**Monks Orchard Residents'
Association
Planning**

Reference:	23/02734/FUL
Application Received:	Thu 13 Jul 2023
Application Validated:	Thu 13 Jul 2023
Address:	9 - 13 Gladeside Croydon CR0 7RL
Proposal:	This proposal is for the demolition of 3no existing dwellings and the erection of 5no detached dwelling houses of two storey with accommodation in the roof space. 8 car parking spaces are provided plus cycle and refuse storage.
Status:	Awaiting decision
Case Officer:	Christopher Grace
Consultation Expiry:	Wed 29 Aug 2023
Determination Deadline:	Thu 07 Sep 2023

Please accept the following assessment by MORA of the Planning Application proposal Application Reference 23/02734/FUL at: 9-13 Gladeside Croydon CR0 7RL for the demolition of 3no existing dwellings and the erection of 5no detached dwelling houses of two storey with accommodation in the roof space. 8 car parking spaces are provided plus cycle and refuse storage.

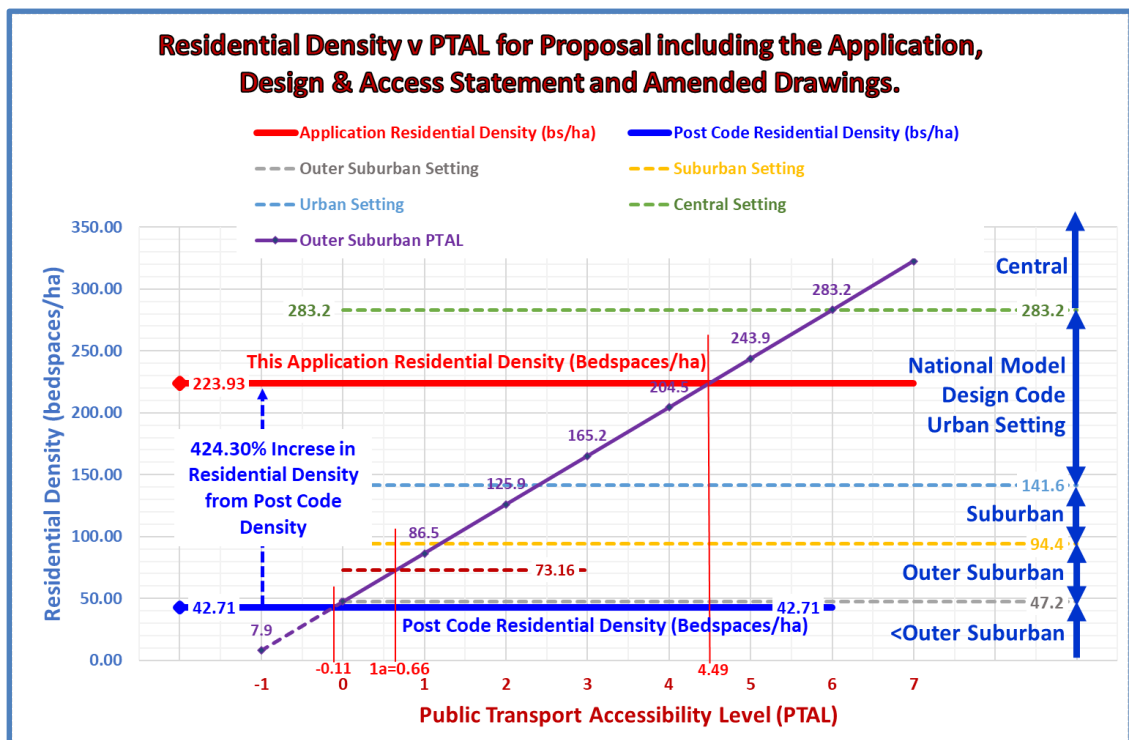
3.4.3.1 The Spreadsheets and Graphical illustrations (above) clearly place the proposed development in a **Post Code (CR0 7RL) Area Type** of less than **“Outer Suburban”** i.e., **<Outer Suburban Area Type Setting** in terms of **Housing Density (Units/ha)** as defined by the **National Model Design Code & Guidance** when the proposal would require a mid-range **Outer Suburban Area Type setting**. i.e., one Area Type higher.

3.4.3.2 The proposal would present a **Housing Density** of **31.99Units/ha** at the mid-range of an **Outer Suburban Area Type** setting in a **predominantly <Outer Suburban Area Type** at **Post Code (CR0 7RL)** of **17.09Units/ha** which is an increase in **Housing Density** of **87.19%** above the predominant **Post Code Area Type setting**.

Graphical illustration of Residential Density v PTAL and Area Types

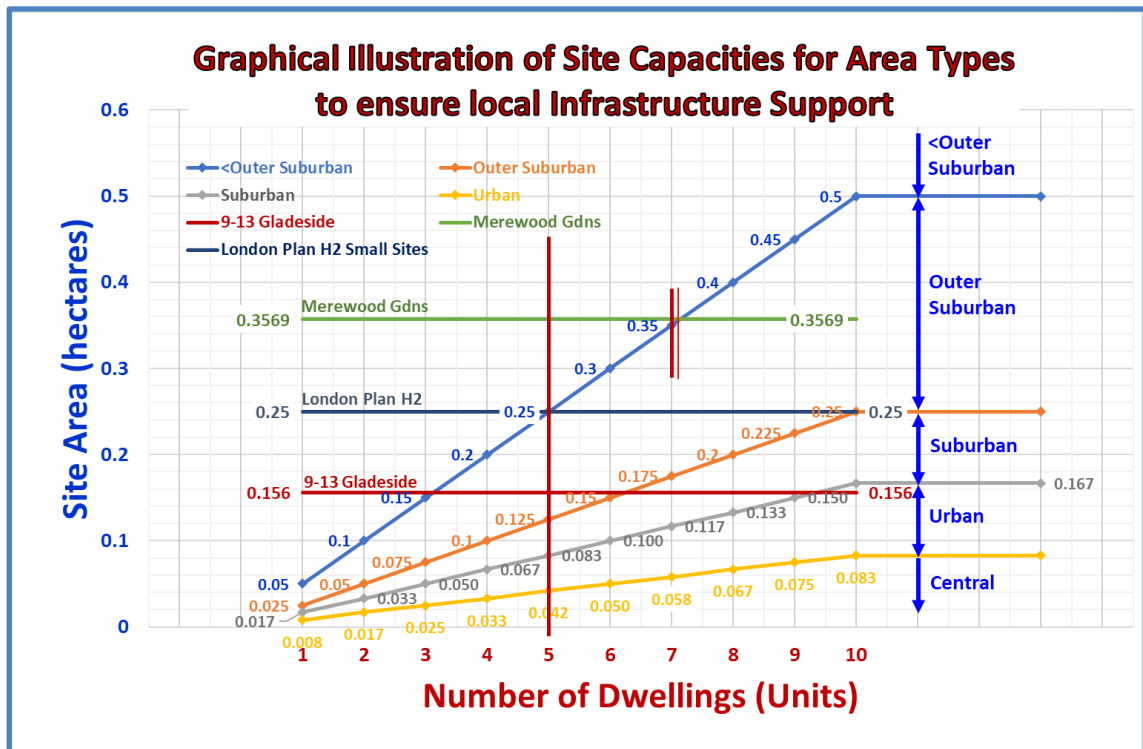
3.4.4.7 This analysis clearly shows the proposal fails to meet the **London Plan Policy D2** as it exceeds the **Area Type Density** for **<Outer Suburban** and would require a **PTAL** to support an **Urban Area Type PTAL** of **4.49** which illustrates that the proposal exceeds “the provision of future planned levels of **infrastructure** rather than existing levels or be proportionate to the **site’s connectivity and accessibility** by walking, cycling, and **public transport** to jobs and services.”

The 45-Degree projection (Vertical) from 7 Gladeside projection intersects Unit 1 & separation between Units.

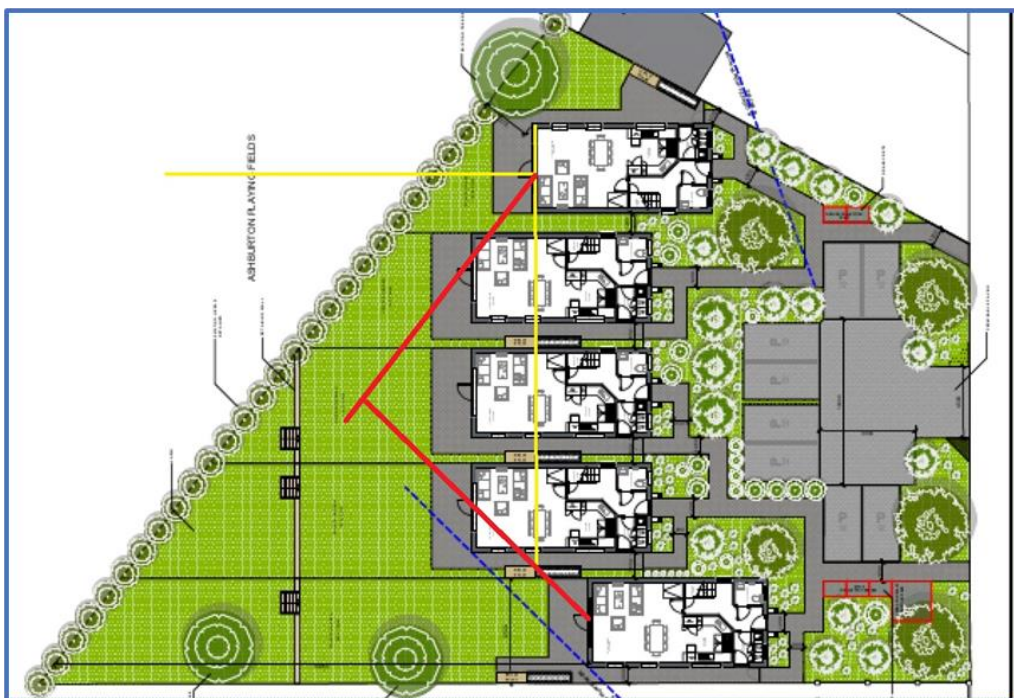
- 4.4 The applicant has **NOT** provided a rear elevation of either Number 7 **Gladeside** or **Unit 1** or **Unit 5** to illustrate the vertical **45-Degree** projection from **Number 7 Gladeside** toward **Unit 1** and **Number 15 Gladeside** to **Unit 5**. However, **Unit 5** distance from **Number 15** and at an angle away from **Unit 5** is such that it does not present a **45-Degree** projection problem.

- 4.5 The projection from **7 Gladeside** does fail the **45-degree vertical** projection assuming the nearest ground floor rear window is a habitable room and is positioned similarly to the front ground floor window as shown above. It is quite probably nearer the boundary and thus would worsen the projection intersection with **Unit 1**.
- 4.6 The rear ground floor has patio doors central to the width of the dwelling and therefore the **45-Degree Projection** is from the centre of these patio doors. The **45-Degree projection** (Vertical) therefore also applies to Units 1&2, 2&3, 3&4, and 4&5, which all fail the rule to a greater or lesser extent within the proposed development.
- 4.7 **45-Degree Horizontal Projection.**

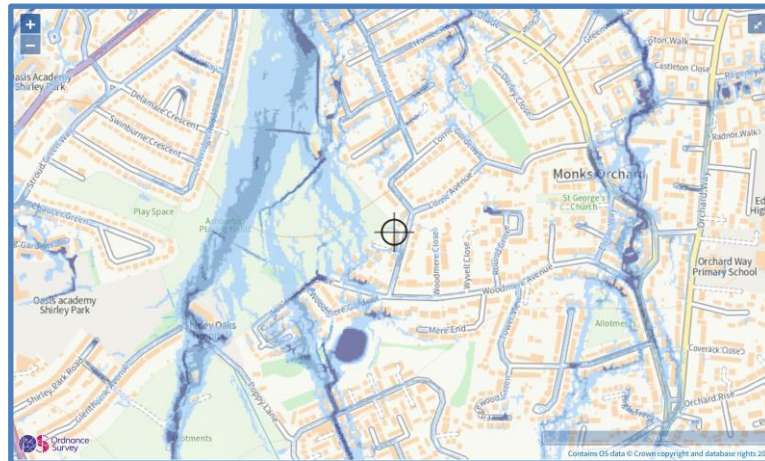
7.4.6 The proposal does **NOT** address the problem of the additional surface water flood risk to nos., **7 and 15 Gladeside** resultant on the **300mm to 600mm** increased height above **AOD** of **Units 1 & 5**. The **Site Area** open to the elements is:

7.4.7 The applicant should stipulate if and what amount the site level open to the elements should be reduced in height to mitigate against this possible surface water flood risk to the adjacent dwellings.
